Official Transcript of Proceedings
NUCLEAR REGULATORY COMMISSION

Title: Advisory Committee on Reactor Safeguards
 592nd Meeting: Open Session

Date: Thursday, March 8, 2012

592nd MEETING

Chapter 6 - Key Confirmatory Analysis Performed by the NRC staff

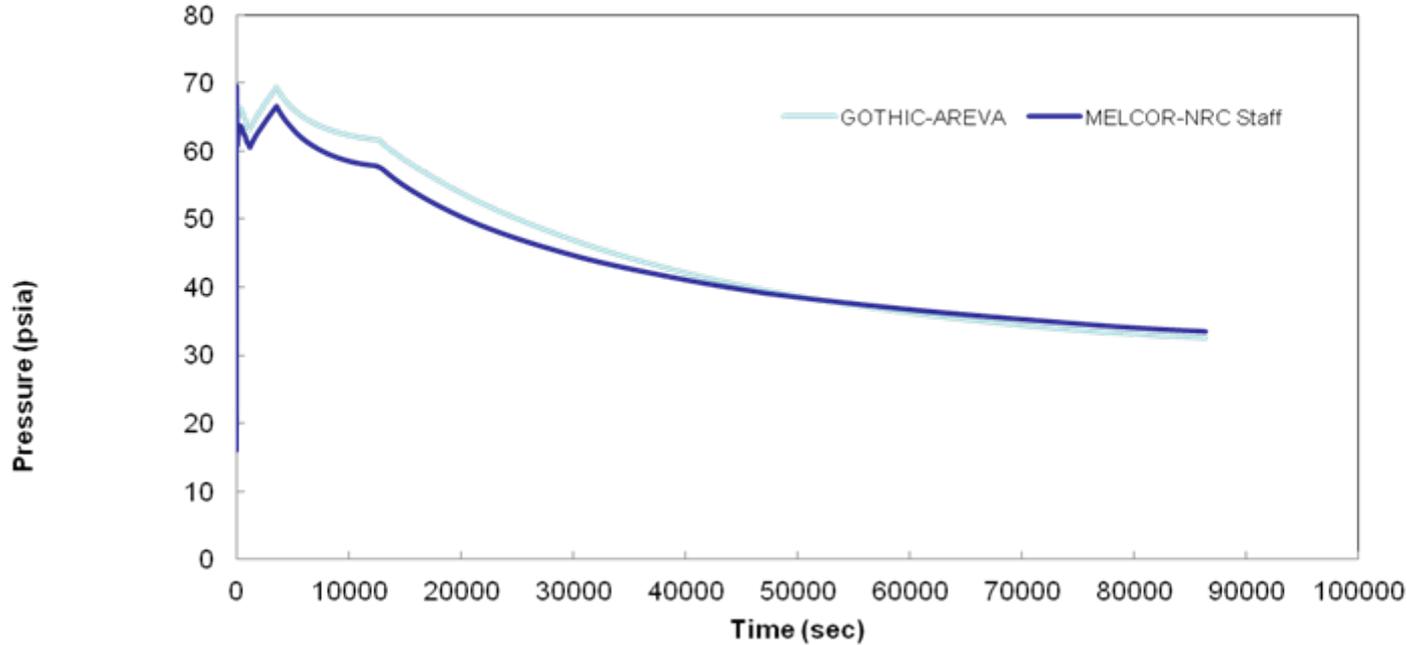
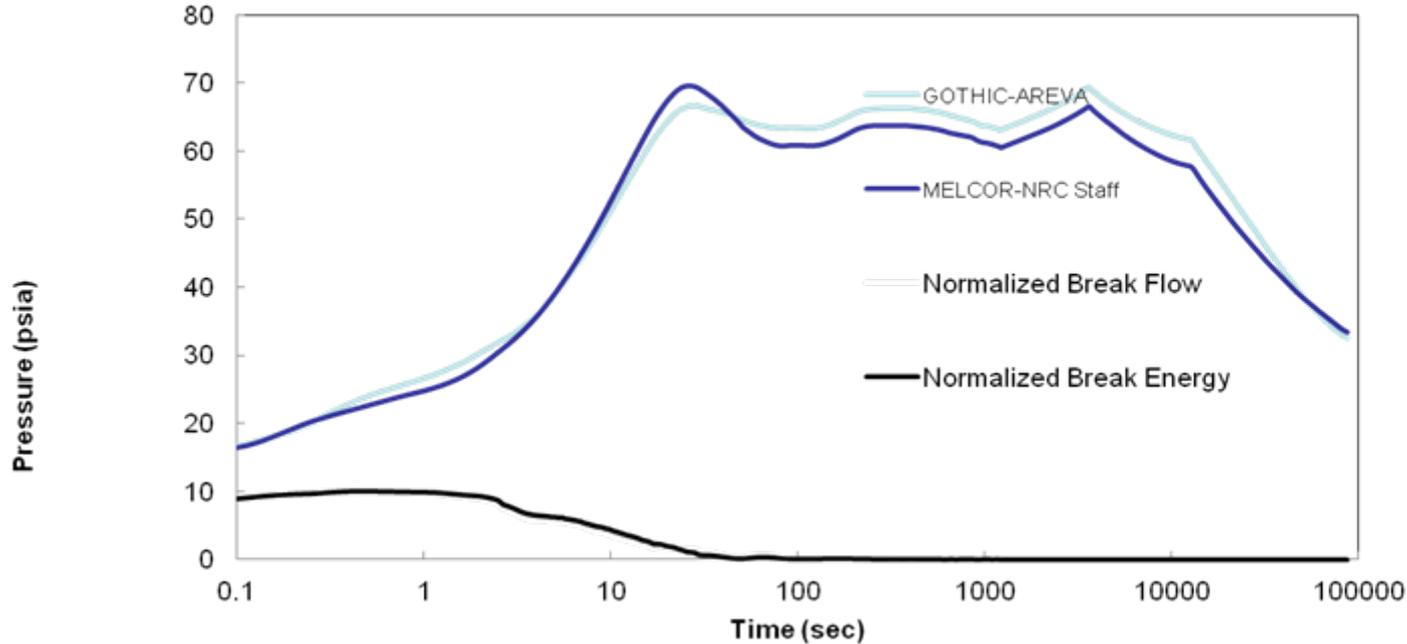
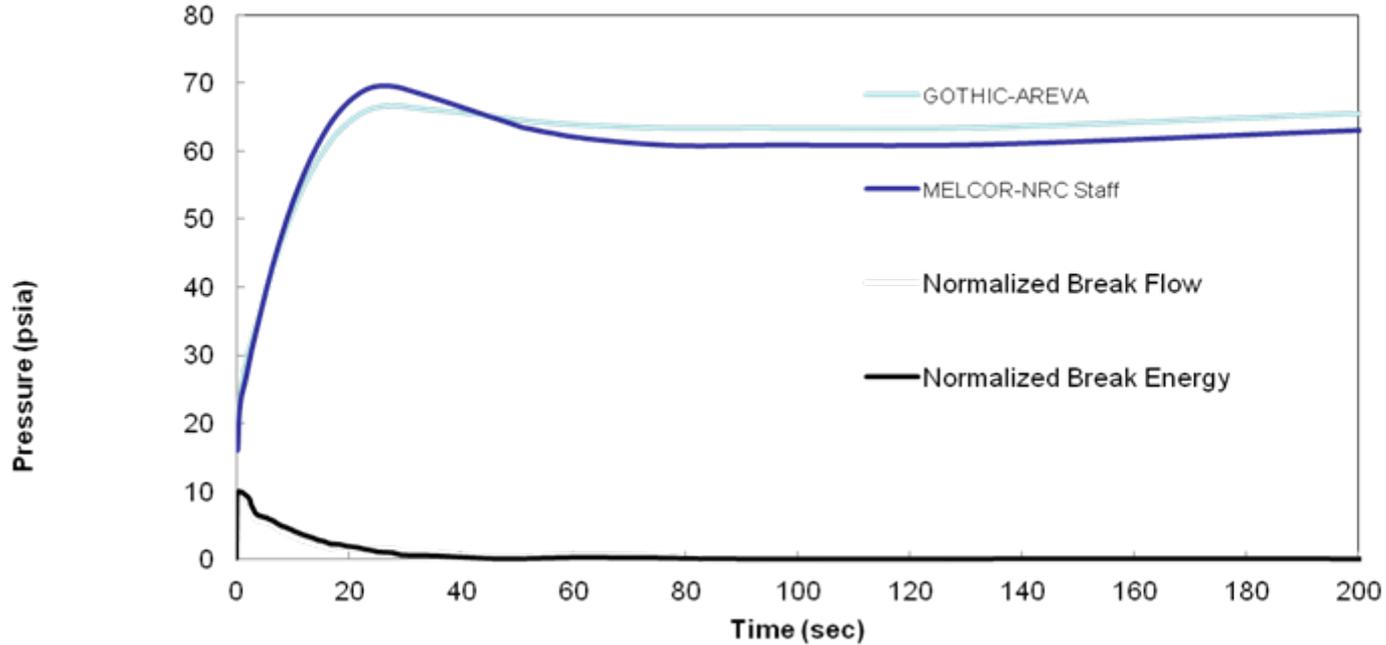
1 to our SRP we need the containment ratio to be less
2 than 50 percent of the peak at the end of 24 hours.
3 So, this will show that they already meet the
4 requirement. It means that heat is more resistance
5 capable to decay of this accident.

10 Oh, by the way, the GOTHIC and MELCOR both
11 has been V&Ved completely. And the testing to decide
12 these capabilities show that GOTHIC can have about 3
13 psi over prediction of the major value. And MELCOR can
14 have 4 psi over the test results.

U. S. EPR Unique Design – Self-Powered Neutron Detector (SPND) Based Reactor Trips:

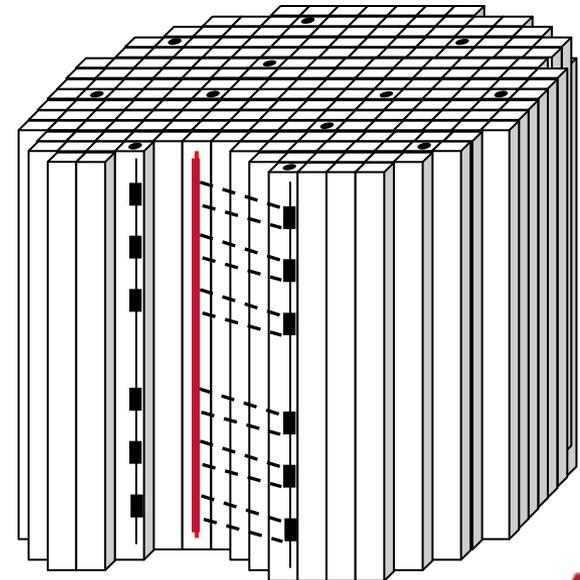
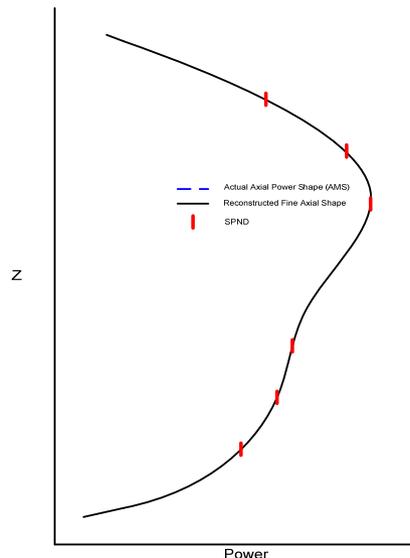
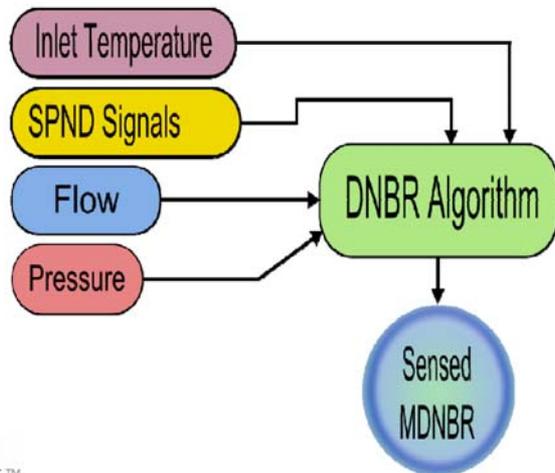
16 MEMBER BROWN: Flip back just one moment
17 just to clarify something. Try to trigger my memory.
18 The 72 SPND signals are needed in all four, that means
19 all 72 detectors feed all four channels?

11 MEMBER REMPE: Could you talk a little bit
12 more about the SPNDs? Are they all the same emitter?
13 How about your lifetime, are you planning ever
14 refueling outage you're going to have to replace them
15 or how long do they last?

13 MR. LU: That's the question. And
14 actually, this was one of the questions the staff
15 between Reactor Systems and Digital I&C Branch we
16 cannot resist questioning them. I think we identified
17 the issue and had similar questions as what's the
18 impact to the detect of the DNBR and the linear
19 generation rate.

20 MR. STACK: That's correct.
